Request for Additional Information No. 89 (1179, 1181), Revision 0

U. S. EPR Standard Design Certification

AREVA NP Inc.

Docket No. 52-020

Figure 9.4.1-2—Control Room Recirculation Air Handling Subsystem

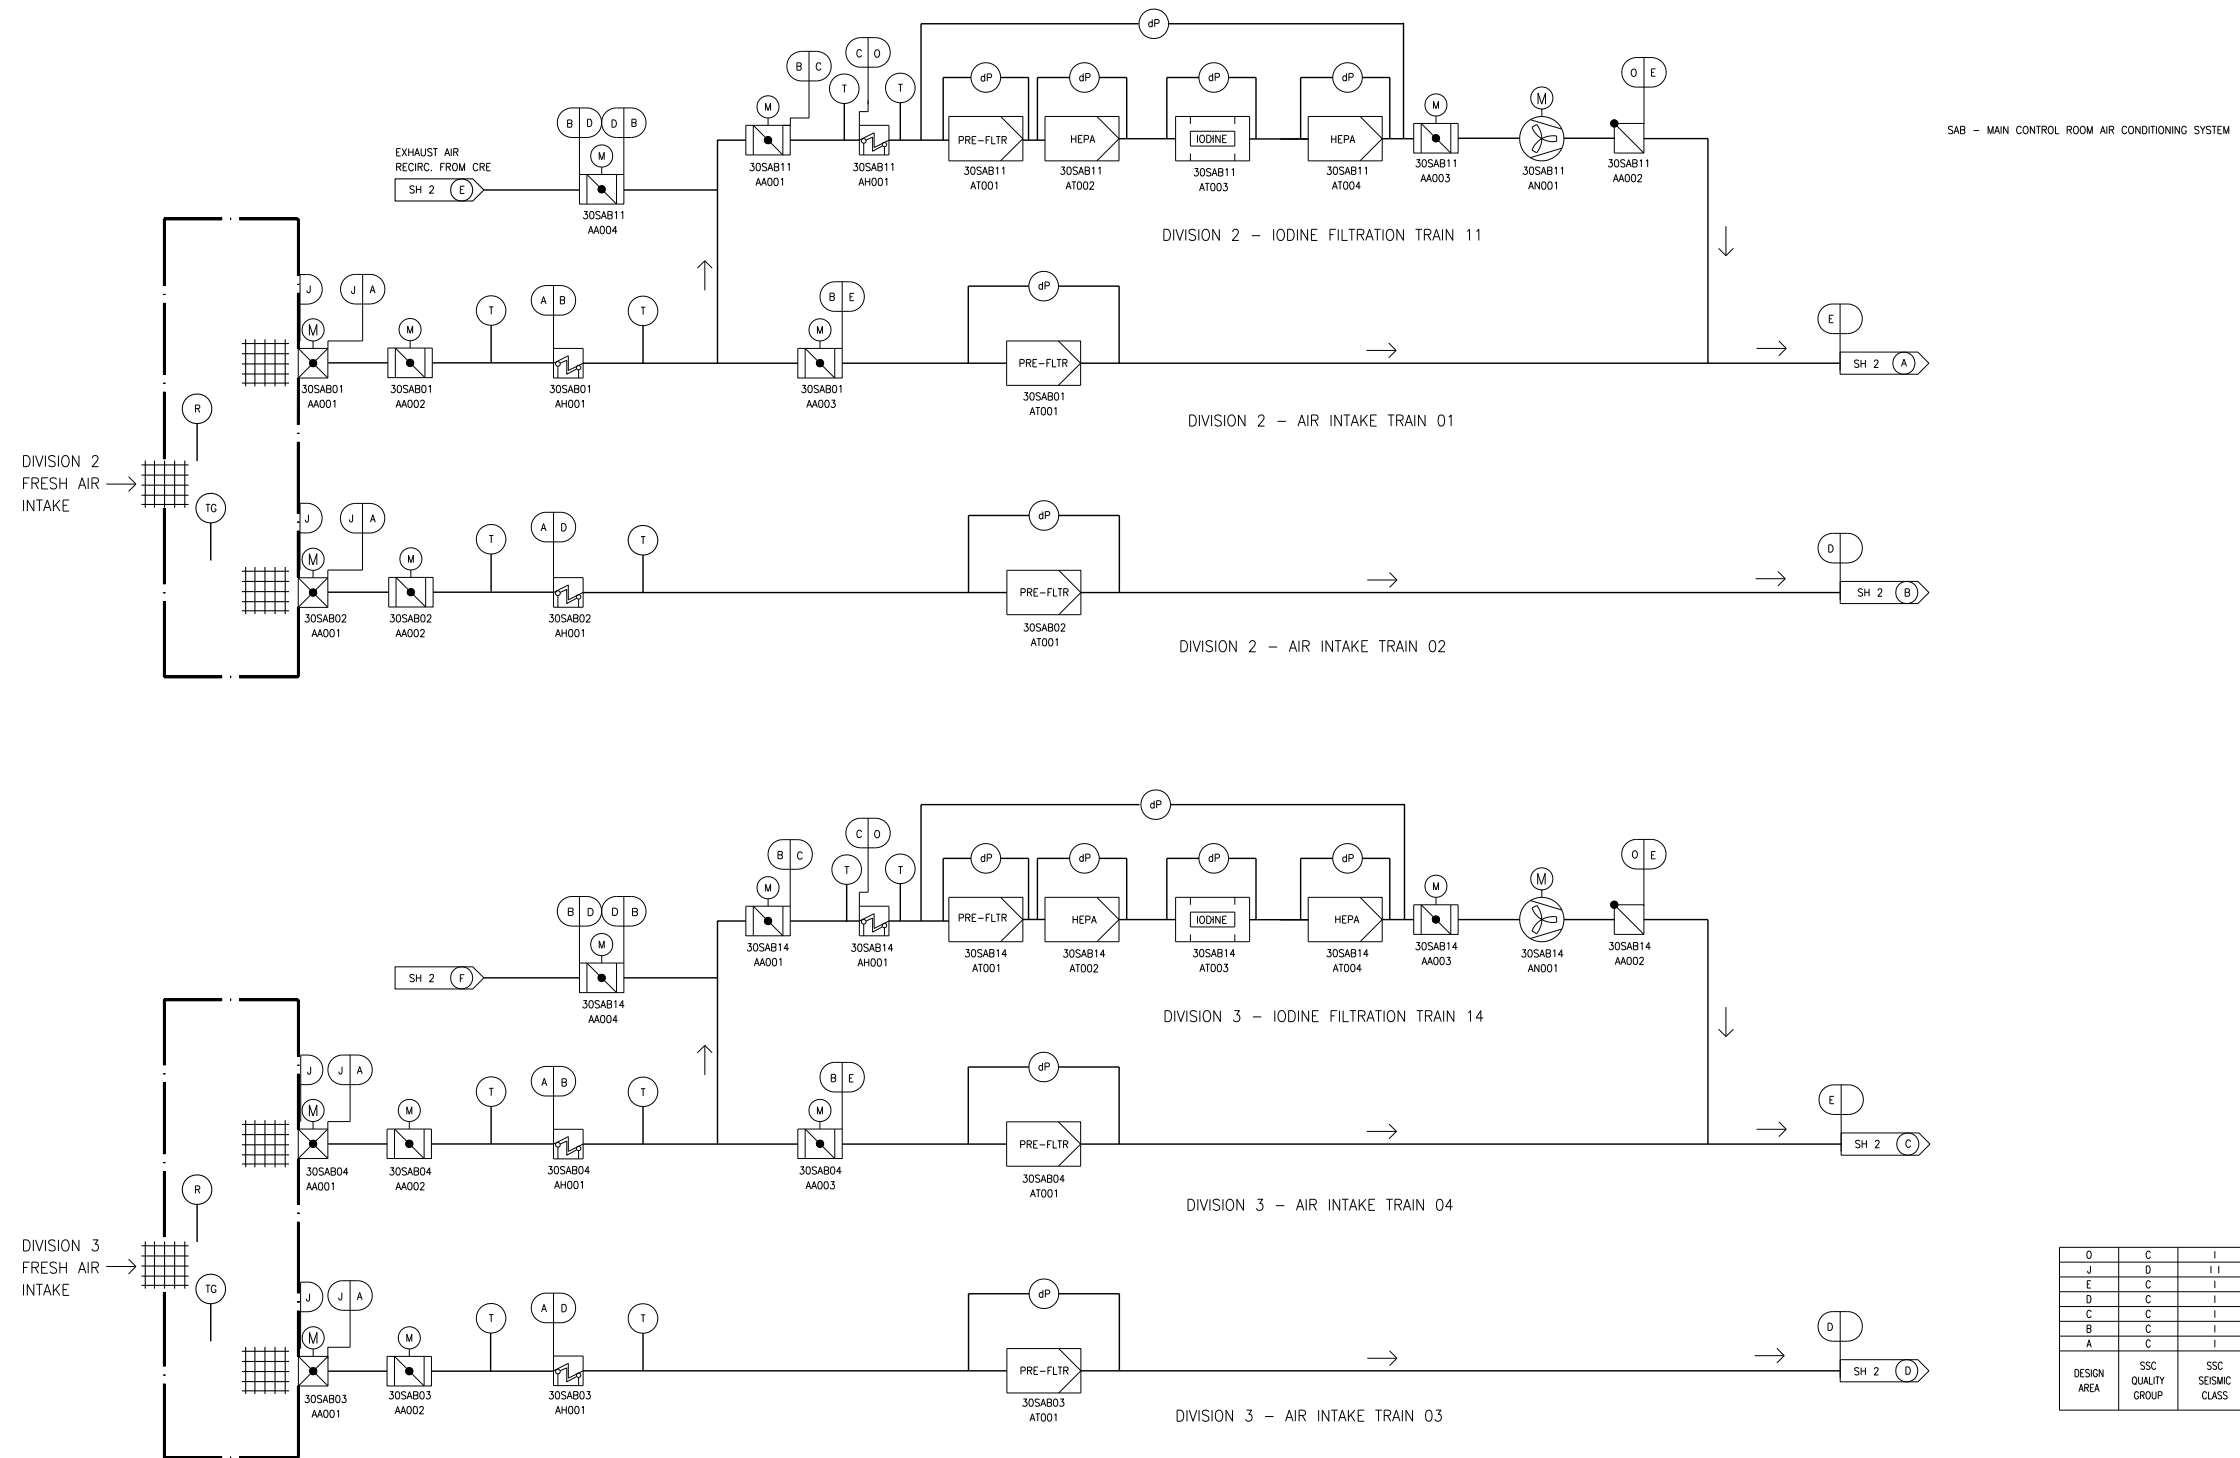
The use of conceptual design information for the control room design basis is not appropriate. Remove the conceptual design basis information from the control room description (FSAR Chapter 6.4). Interface requirements like toxic gas evaluations should be identified as specific COL information items rather than be designated as conceptual.

06.04-4
TG-Toxic Gas Sensors
